10/550,551

Office Action Summary	Application No. 10/550,551	Applicant(s) BEHAR ET AL.	
	Examiner ROBERT K. NICHOLS II	Art Unit 3754

DETAILED ACTION

**Marked-up Figure 14**

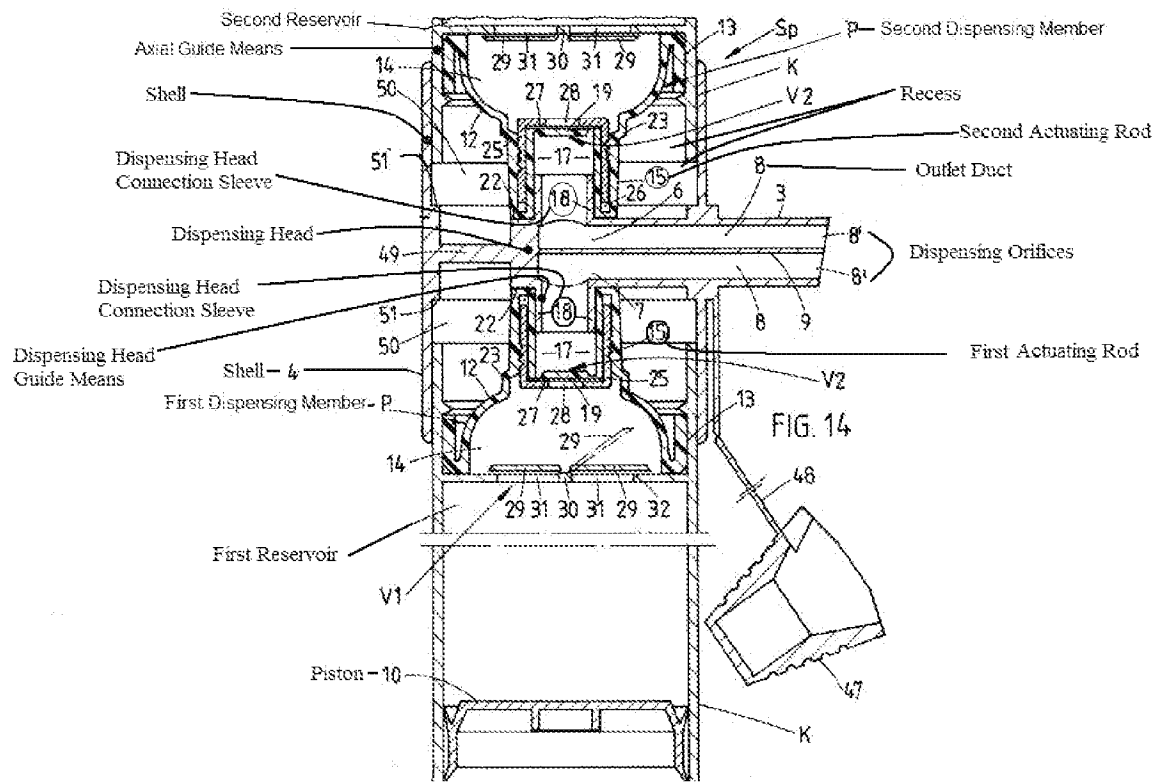
Regarding claims 1 and 2, Schuckmann discloses a dispenser including a first fluid dispenser member associated with a first fluid reservoir, wherein the first member includes a first actuating rod mounted to move along the rod axis between a rest position and an actuated position. Schuckmann further discloses a second fluid dispenser member associated with a second fluid reservoir, wherein the second member includes a second actuating rod mounted to move along a second rod axis between a rest position and an actuated position. Schuckmann additionally discloses that the first and second rod axes coincide (see marked-up figures 11 and 14).

Schuckmann additionally discloses the first rod having a free end pointing in a first direction and a second rod having a second free end pointing in a second direction, the two members being disposed one relative to the other with the first and second rod axes extending parallel and with the first direction being opposite to the second direction, so that one dispenser member is disposed upside down relative to the other dispensing member (see marked-up figures 11 and 14).

Furthermore, Schuckmann discloses the reservoirs to be airless reservoirs with their volumes decreasing as fluid is extracted therefrom. In addition, Schuckmann discloses one of the dispenser members to be provided with a load adjustment spring 12 suitable for modifying the actuation load of one of the dispensing members (see marked-up figure 14 and page 1 of translation).

Regarding claim 5, Schuckmann discloses the pusher forms a recess for receiving a fluid reservoir (see marked-up figure 14).

Regarding claims 6 and 7, Schuckmann discloses the pusher being provided with axial guide means for axially moving the second reservoir that it drives. Schuckmann further discloses the reservoirs being received in a shell 4, a dispenser head that is common to both of the dispenser members being mounted to slide axially in the shell 4, wherein the pusher is mounted to slide axially in the shell 4 (see marked-up figure 14).

having two connection sleeves communicating with the duct outlet and each receiving a respective free end of the respective actuating rods, the two sleeves being constrained to move with each other (see marked-up figure 14).

Regarding claim 9, Schuckmann discloses the dispensing head forms guide means for dispensing (see marked up figure 14).

Regarding claim 12, Schuckmann discloses at least one of the reservoirs is chosen from the group formed of follower piston reservoirs and of variable-volume flexible pouches (see marked-up figure 14).

**Marked-up Figure 11**

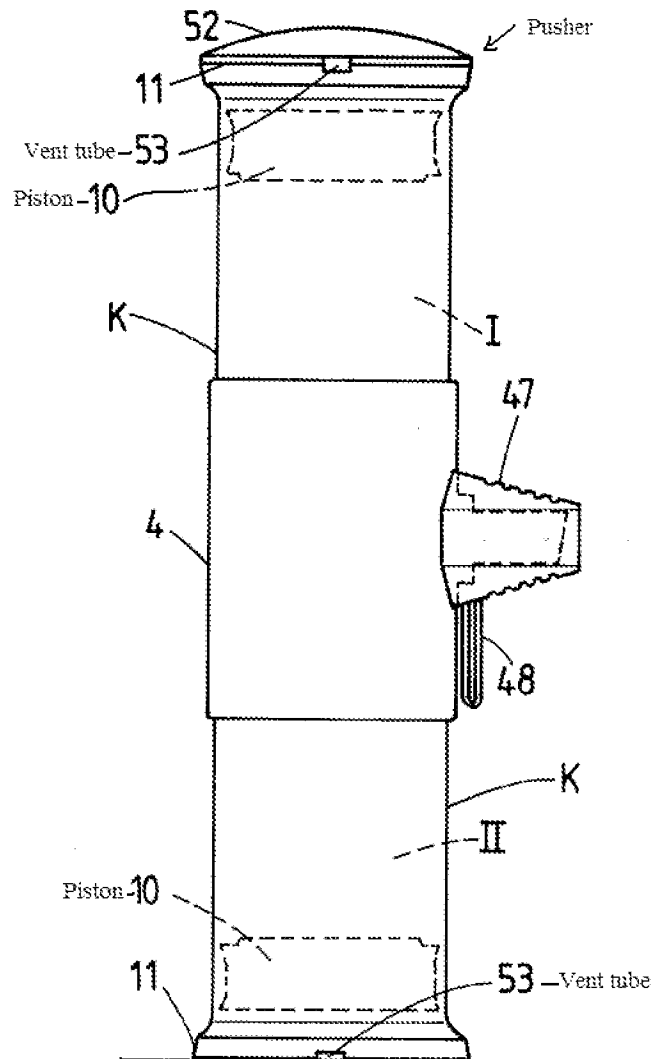
Regarding claim 3, Schuckmann discloses a pusher mounted to move along a push axis extending parallel to the rod axes, wherein the pusher subjected to a push force urges one rod free end towards the other rod free end (see marked-up figure 11).

Regarding claim 4, Schuckmann discloses the pusher acts on the first reservoir to move it towards the other reservoir, the actuating rods of the two dispenser members remaining static relative to each other while moving together towards the reservoirs (see marked-up figures 11, 14 and figure 15).

Regarding claim 10, Schuckmann discloses one dispenser member situated above its reservoir and the other dispensing member is situated below its reservoir. Schuckmann further discloses the dispenser member situated below the reservoir being provided with a vent tube 53 that extends inside the reservoir out of the fluid (see marked-up figures 11, 14 and page 7 of translation).
